February 18, 2022

Planning Director John Ford
Humboldt County Planning & Building Department
3015 H Street
Eureka, CA 95501
CEQAResponses@co.humboldt.ca.us

Dear Planning Director Ford,

Fig. A. Water temperatures at the Humboldt Bay Shore Station were several degrees higher than at the Trinidad Pier Station between May and November, 2017. Source: CeNCOOS.

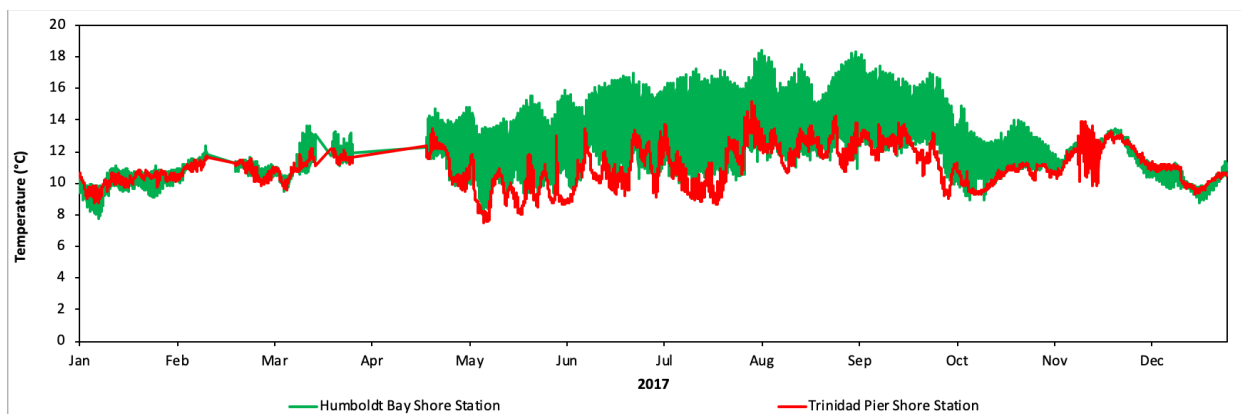
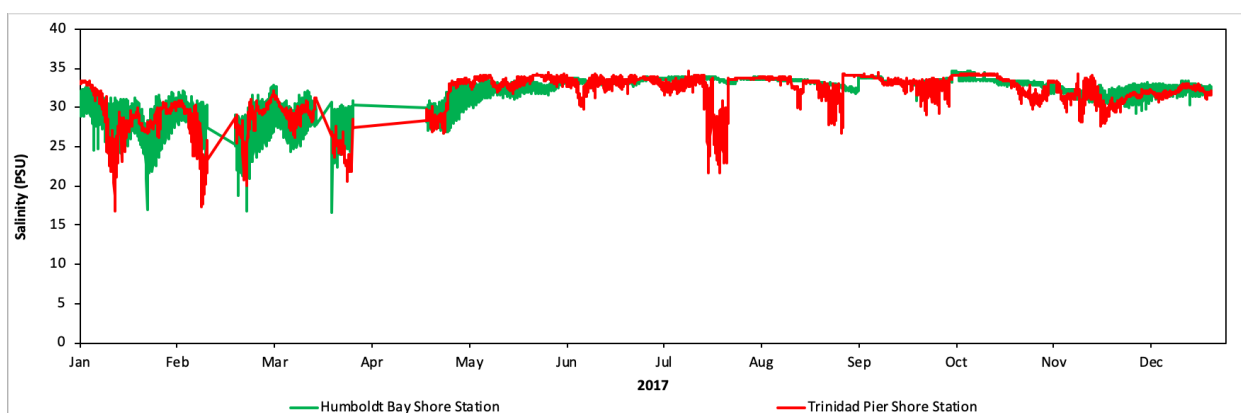
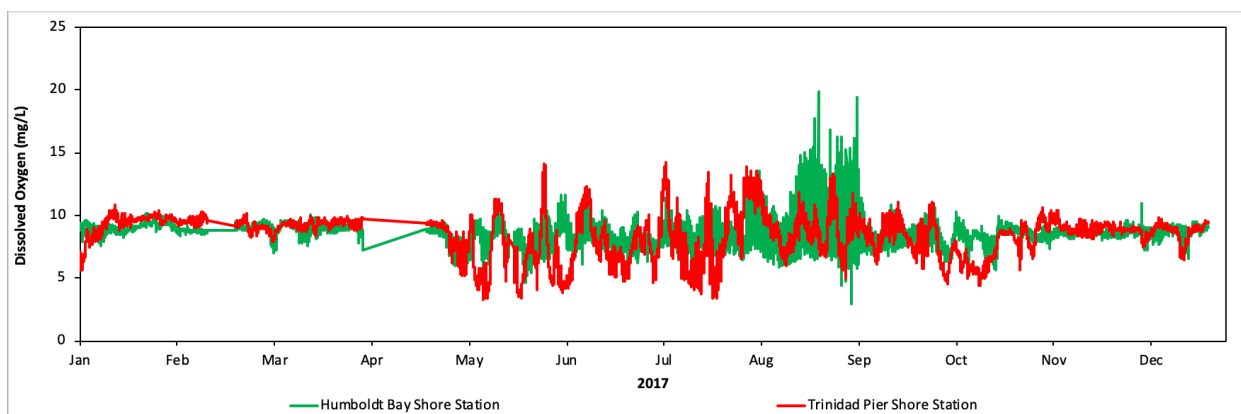
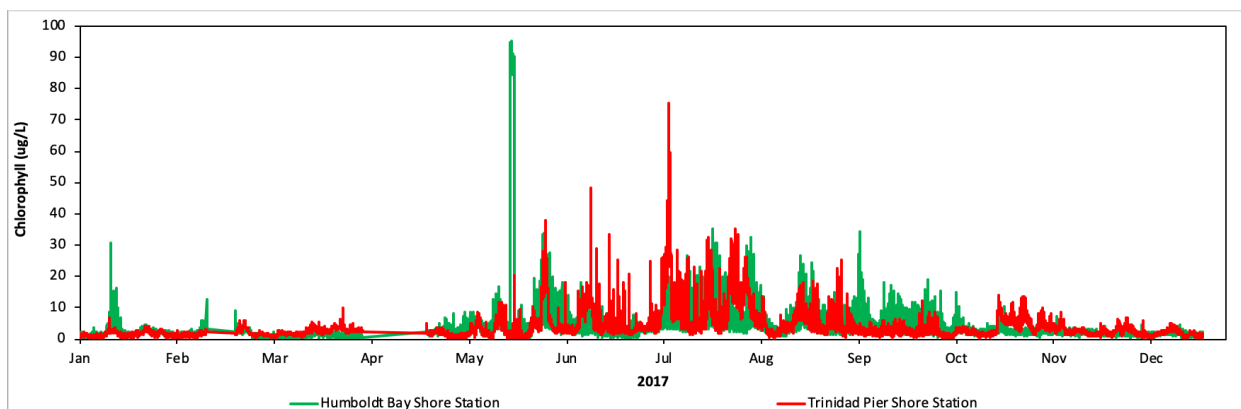
B. Conditions in Entrance Bay are Not Indicative of Ocean Conditions

Figures 3 and 4 from Anderson and Costello-Anderson, 2019.¹³⁶

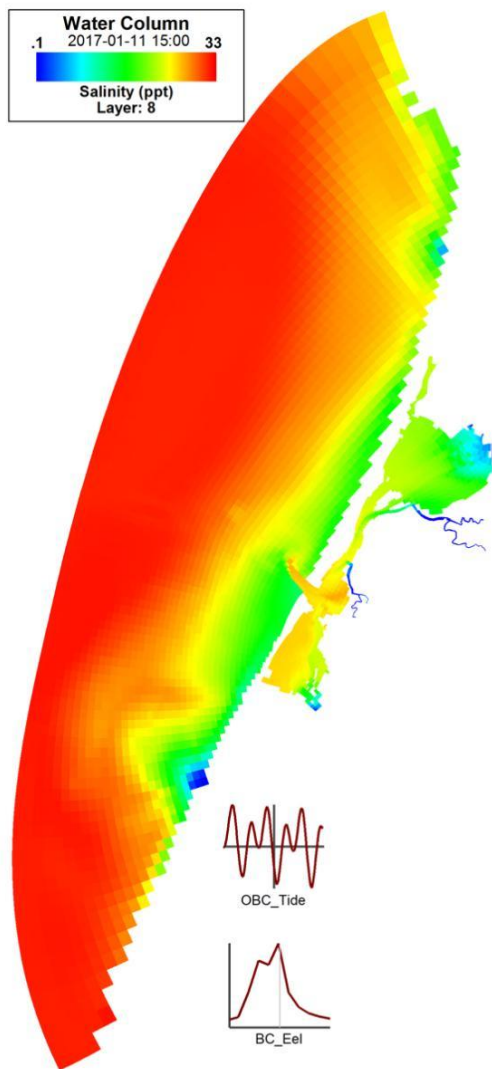
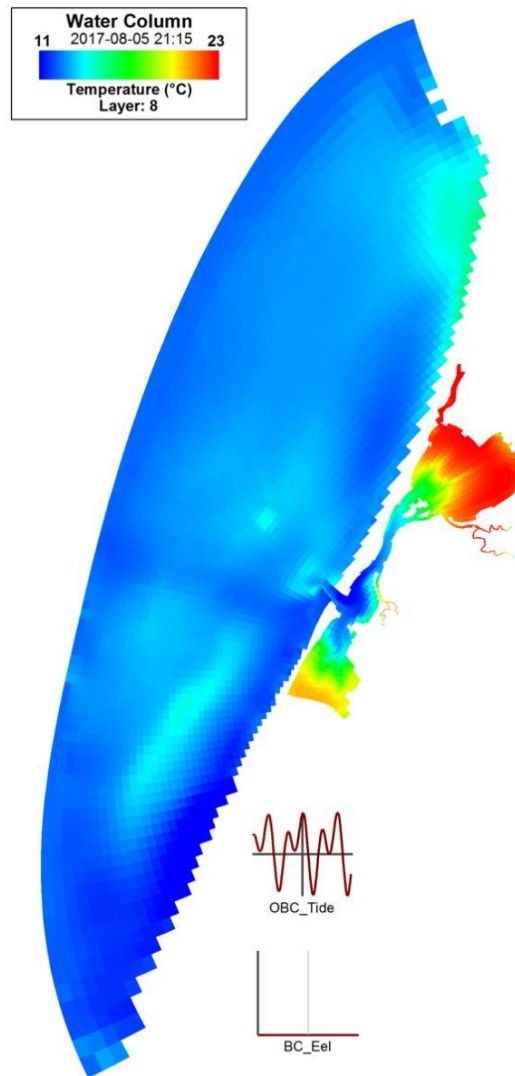
The Numeric Modeling Report¹³³ used to determine there would be no significant impacts from the ocean discharge relied on a hydrodynamic model done in 2010.¹³⁴ The author revised the model in 2019.¹³⁵ The findings strongly suggest that conditions in Entrance Bay are not reliable indicators of ocean conditions. The study showing age-of-water (residence time) of ocean versus Entrance Bay strongly suggests that Humboldt Bay water quality may not be representative of ocean conditions. In this study, the model domain encompasses Humboldt Bay and the adjacent ocean, as well as the Eel, Mad and Little Rivers and major bay tributaries (Elk River, Freshwater and Jacoby Creeks). The calibrated/validated model was used to predict basic physical processes in Humboldt Bay. Anderson's Figure 3 (below) shows the upper grid layer salinity distribution in Humboldt Bay and adjacent ocean during a large rainfall runoff event in 2017. Anderson's Figure 4 (below) shows the summer water temperature pattern with north and south bays having temperatures approximately 10 °C higher than the ocean. Entrance Bay has greater water age, or residence time, than adjacent ocean waters. The difference in temperature and residence time suggest that Humboldt Bay water quality may not be representative of ocean conditions and that further data collection and modeling need to be done at the site of discharge. At a minimum, a sensitivity analysis should be conducted to understand assumptions regarding ambient background data.

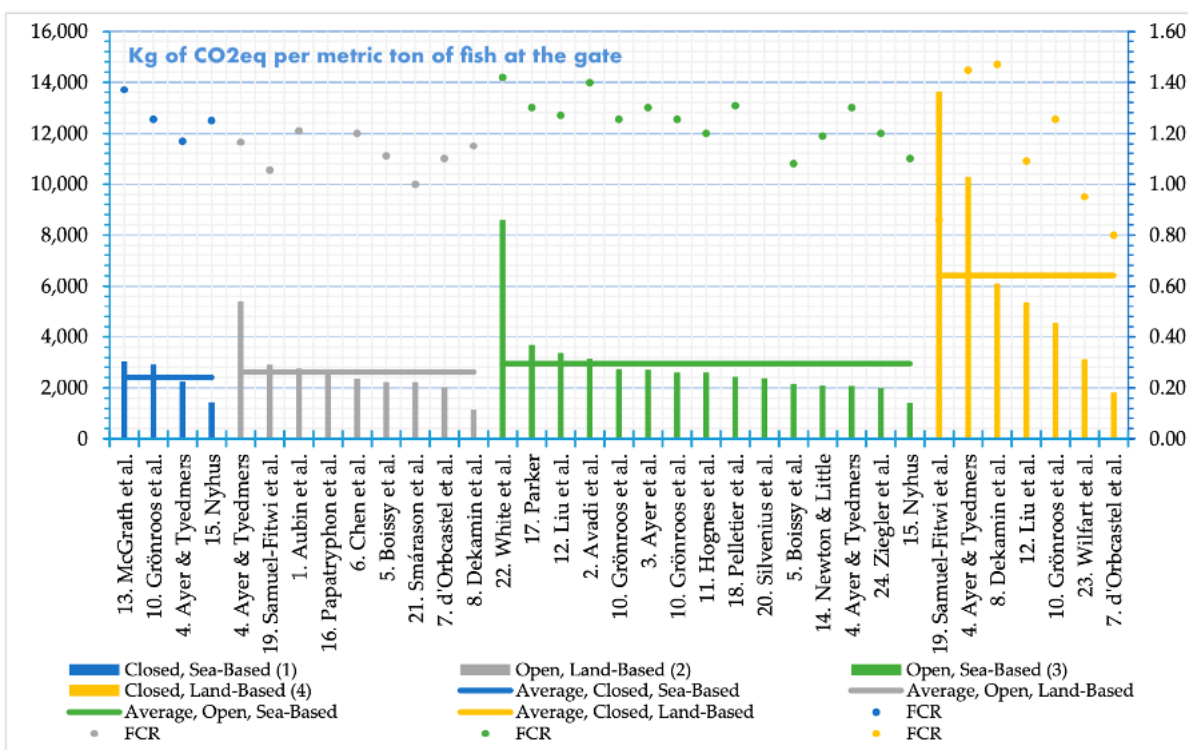
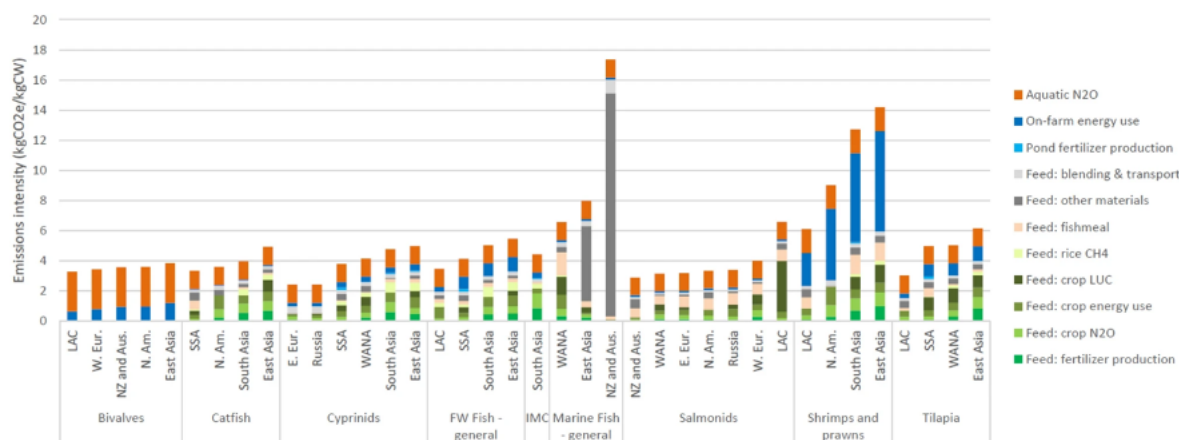
- In 2019,⁵³ a meta-analysis of LCA studies on salmonids (a much broader category than Atlantic Salmon) was performed with important conclusions. Twenty-four studies were found, nine dealing with Atlantic Salmon. The 24 studies were grouped into Open or Closed and Land vs Sea-based, forming four groups. Differences by production grouping are more important than differences by the fish type. The GHG impacts of land based recirculating systems are higher than other models. The three studies we presented above are in line with the averages shown in Figure 1 in the Appendix, with the LBCC-RAS studies showing in yellow. For 25,000 metric tons of fish from Nordic the metric tons of CO₂e would be 150,000 if we use the average.
